RE: Updated Sydney Water advice regarding Response to Submissions for SSD-36138263 Augusta Street Warehouse and Distribution Centre

Sydney Water is writing to you to provide an updated response to the *Response to Submissions* for SSD-36138263 Augusta Street Warehouse and Distribution Centre.

Appendix 1: Registered easements and removed proposed easements

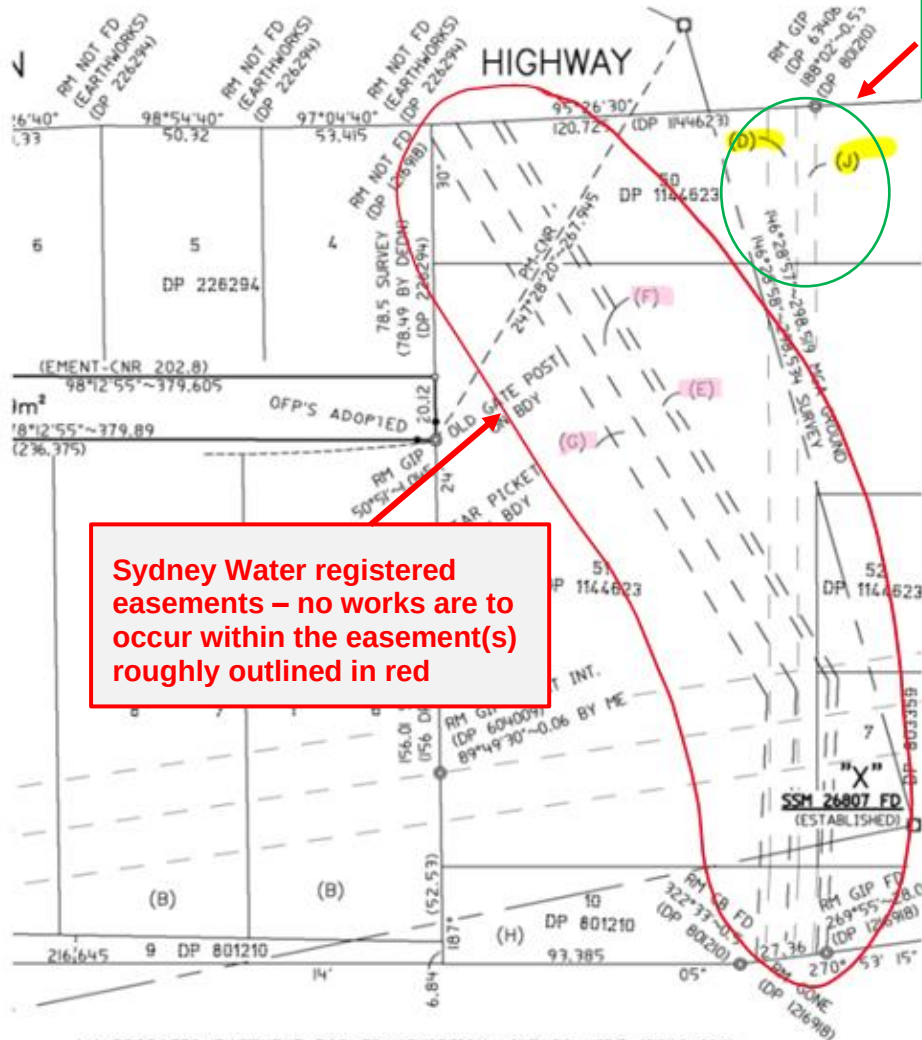
Sydney Water has undertaken further investigations and confirms that removal of some of the previously mentioned proposed easements were undertaken in 2016. However, Sydney Water still has registered easements traversing the property in a north-westerly direction (DP1216918, registered 29 February 2016). These registered easements **may still** be utilised for the delivery and construction of trunk water mains associated with project WP200. In the interests of clarity please see the attached figure in **Appendix 1** that differentiates the easements required from the proposed easements that have been removed.

Sydney Water registered easements – no works are to occur within the easement(s) roughly outlined in red
